Highgate School – Richard’s Music Centre – Carbon Management Planning Responses

Date
8th August 2025

On 10th April 2024, Haringey Council provided a Carbon Management Response (REF: HGY/2023/0315) which confirmed objection to the application. Within this, the Council stated that “*Carbon Management cannot currently support this application. Some clarifications must be provided with regard to the Energy Strategy, Overheating Strategy and Whole-life carbon Assessment. This should be addressed prior to the determination of the application.*” A meeting was held 10th March 2025 between AECOM, Highgate School, Haringey’s Carbon Management team and the Case Officer to discuss the response and comments by the Carbon Management team. AECOM has liaised with the design team in order to respond to the concerns raised. The response tracker below contains the concerns and queries raised by Haringey council and the design team responses to these.

Appendix 4 – Potential spaces that could be used during a heatwave to cool down

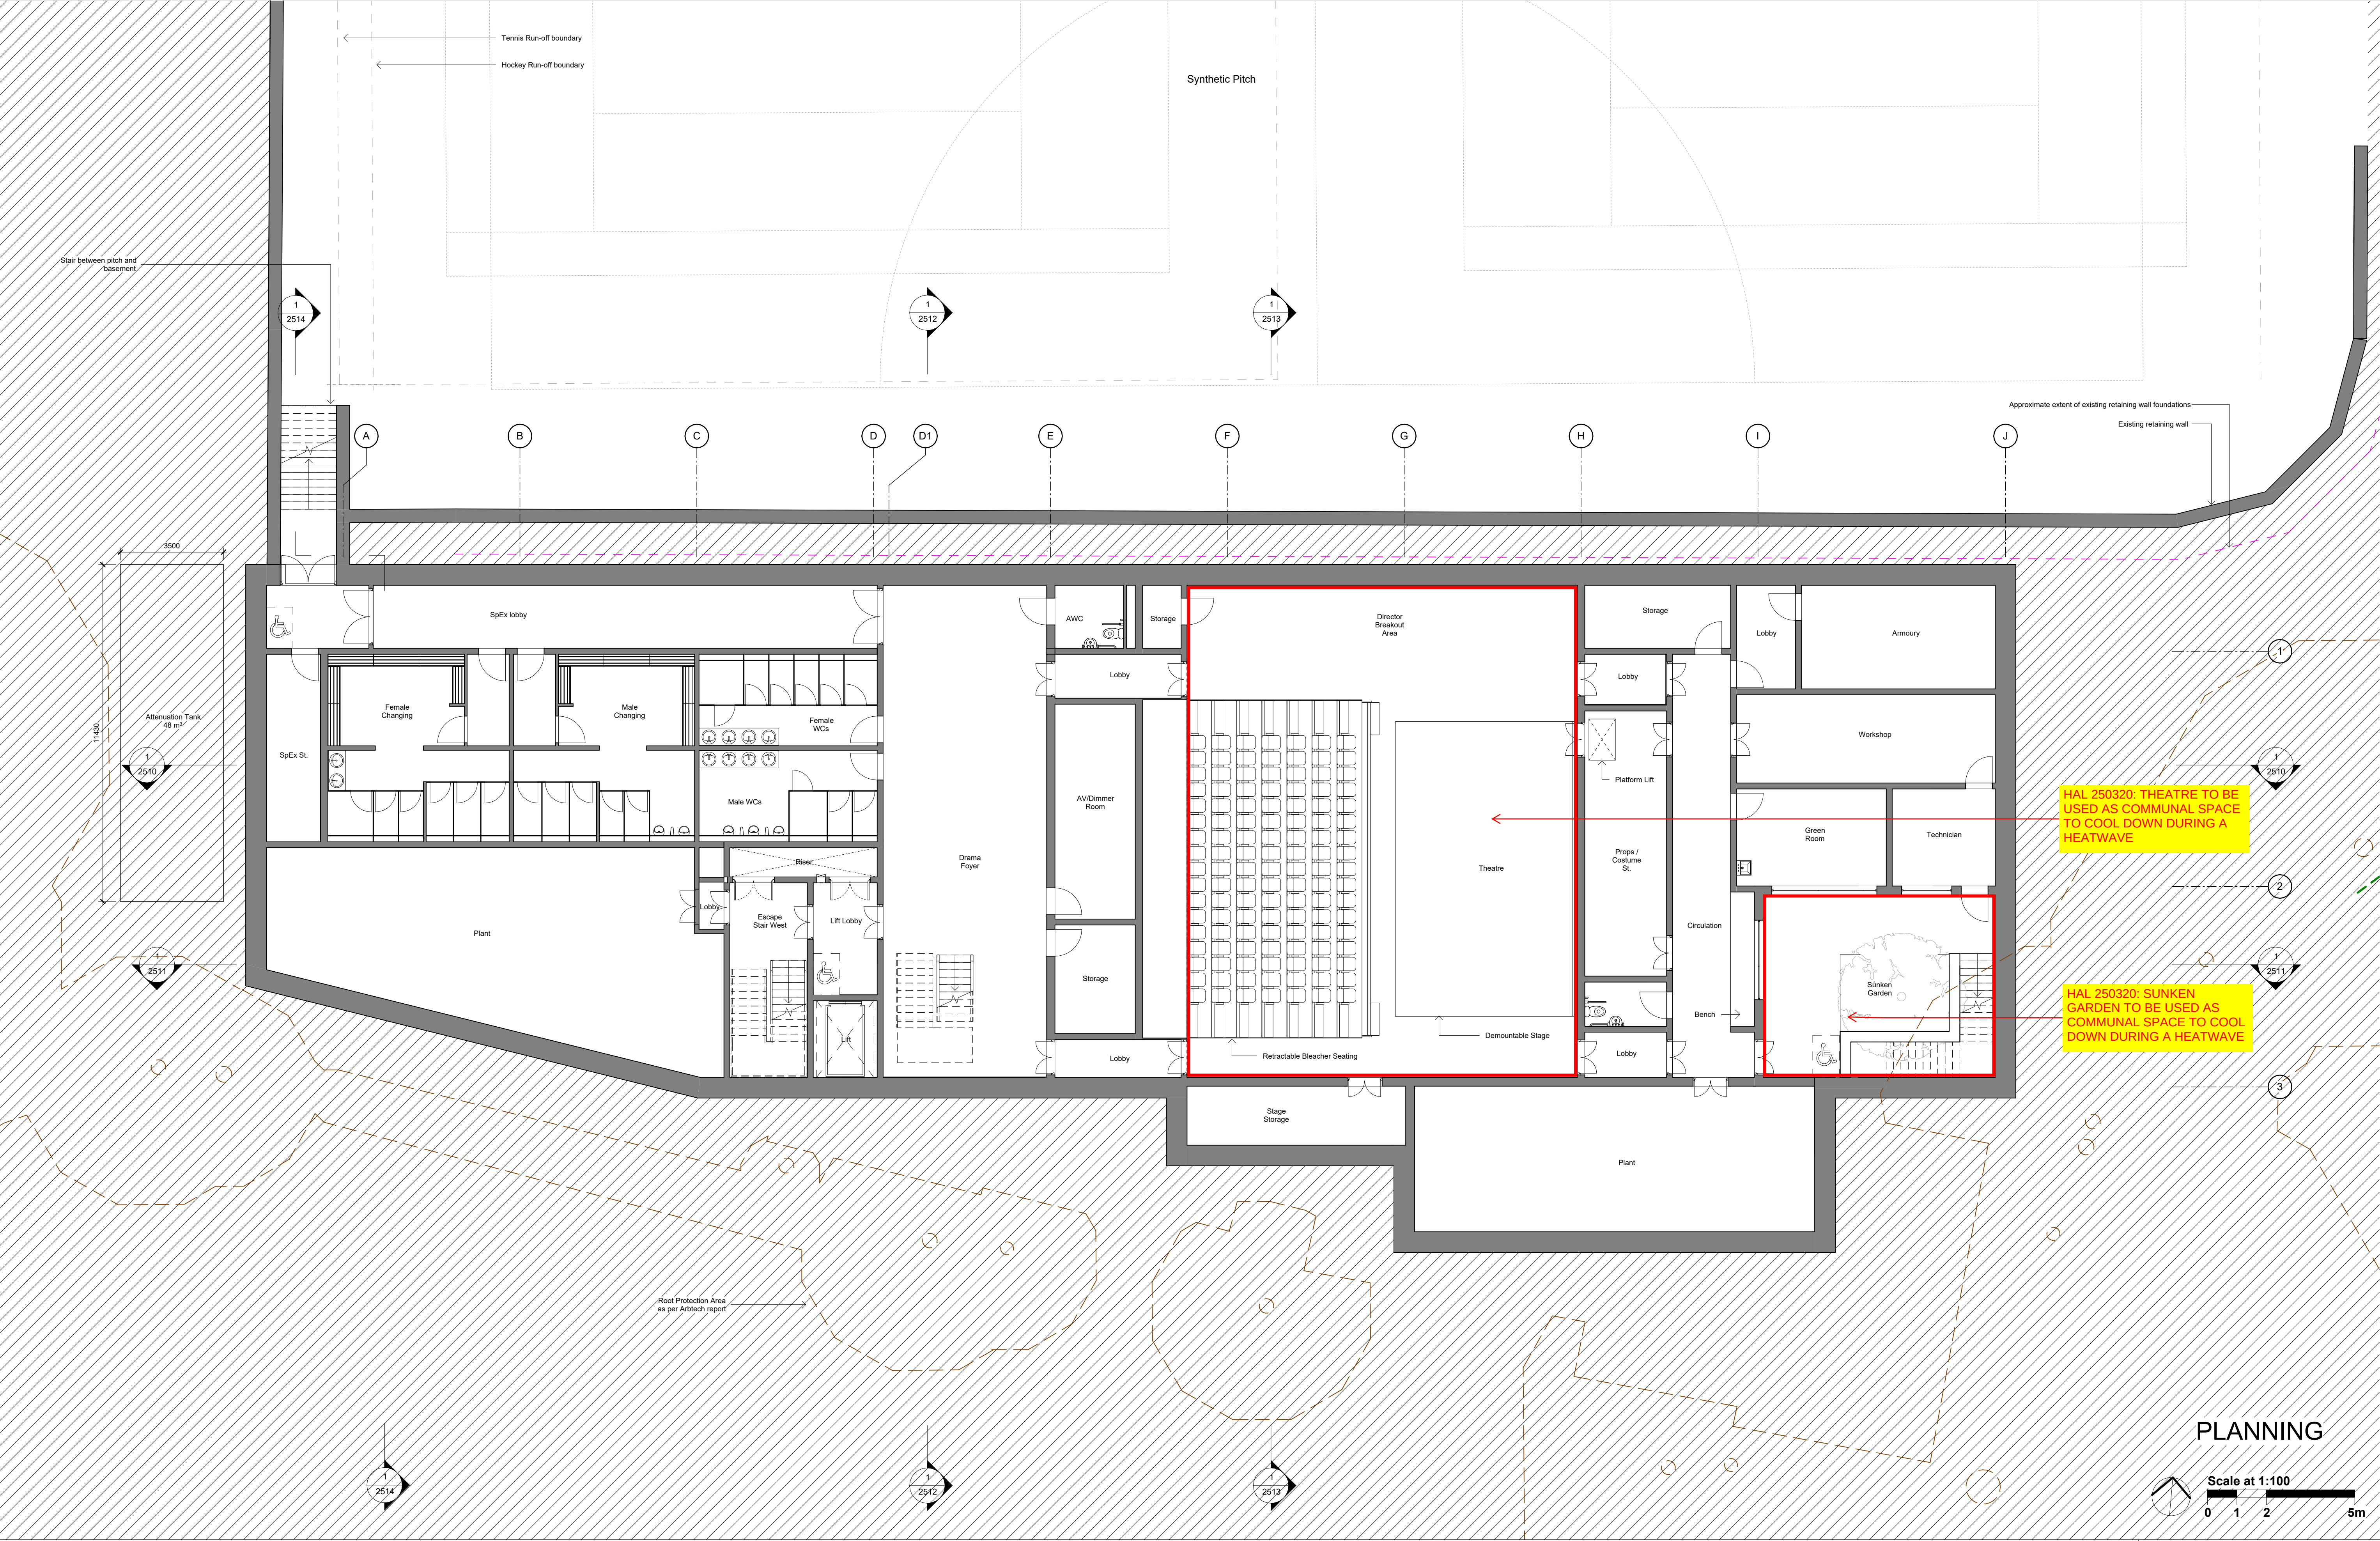
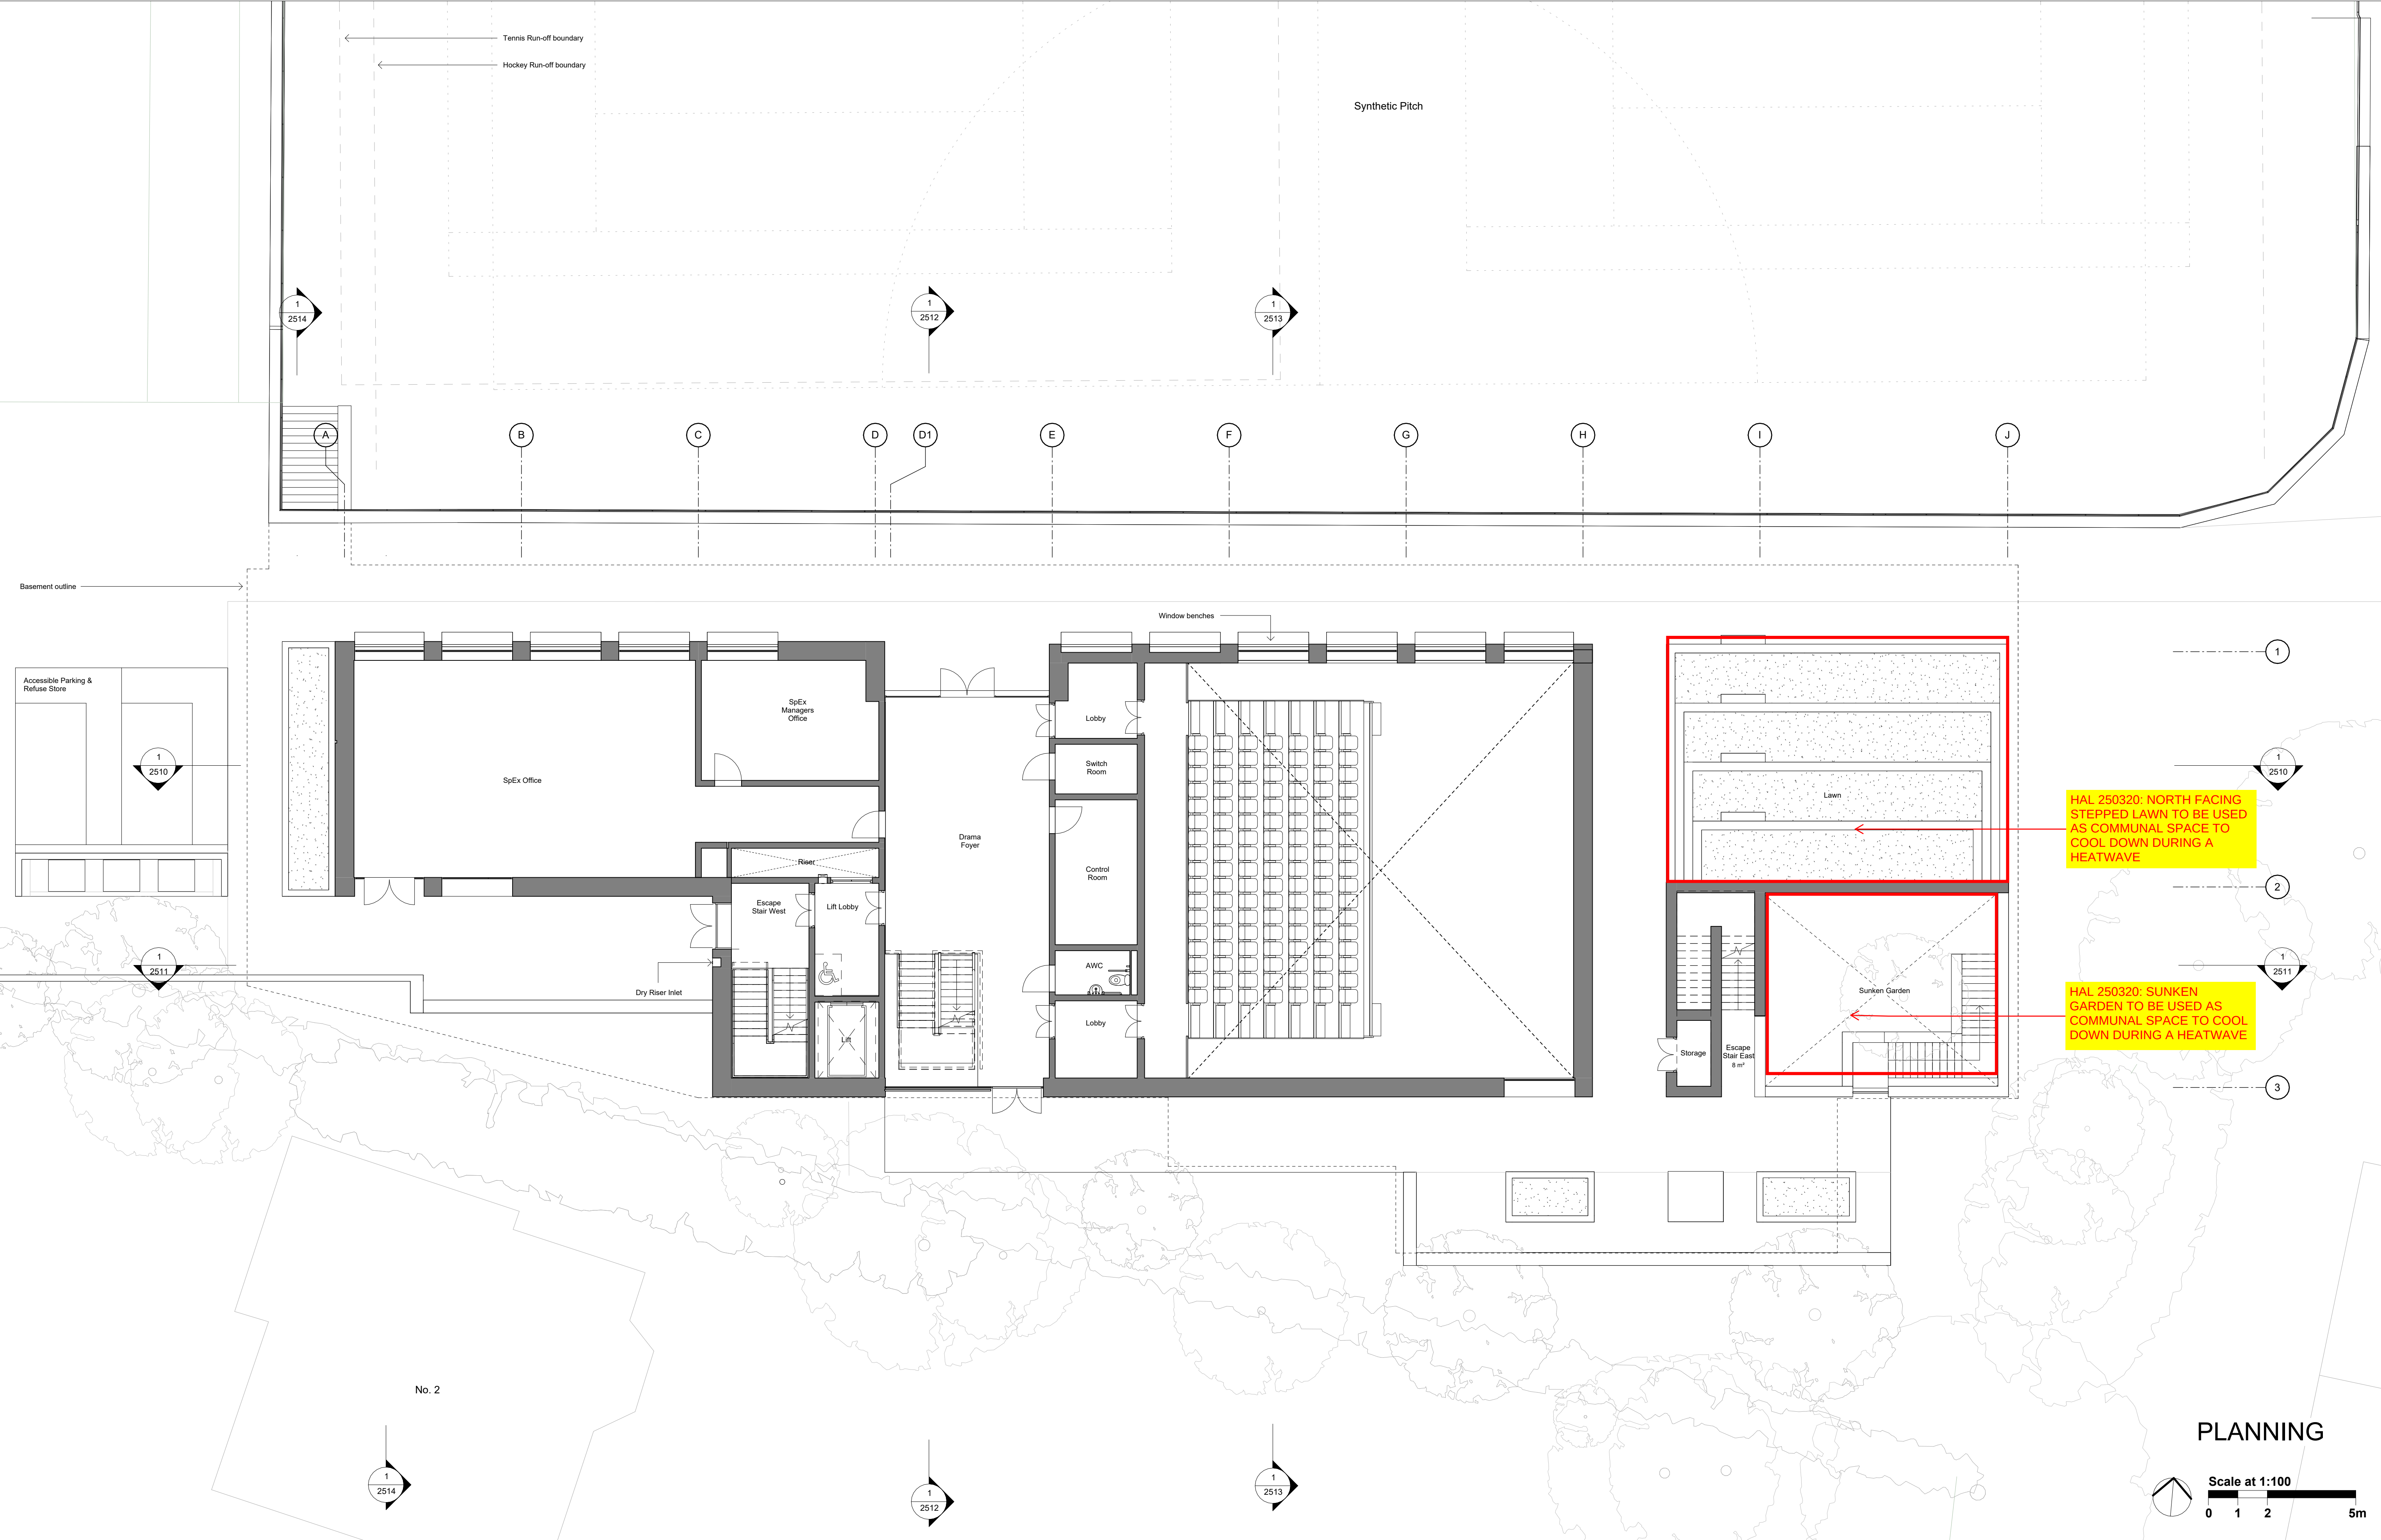
26.	Identify communal spaces (indoor and outdoor) where students and staffs can cool down if the indoor spaces are overheating.	The theatre (the only mechanically cooled internal space), sunken garden and north facing stepped lawn are communal areas where it is proposed that students and staff could cool down if indoor spaces are overheating. These areas are highlighted on drawings provided in Appendix 4
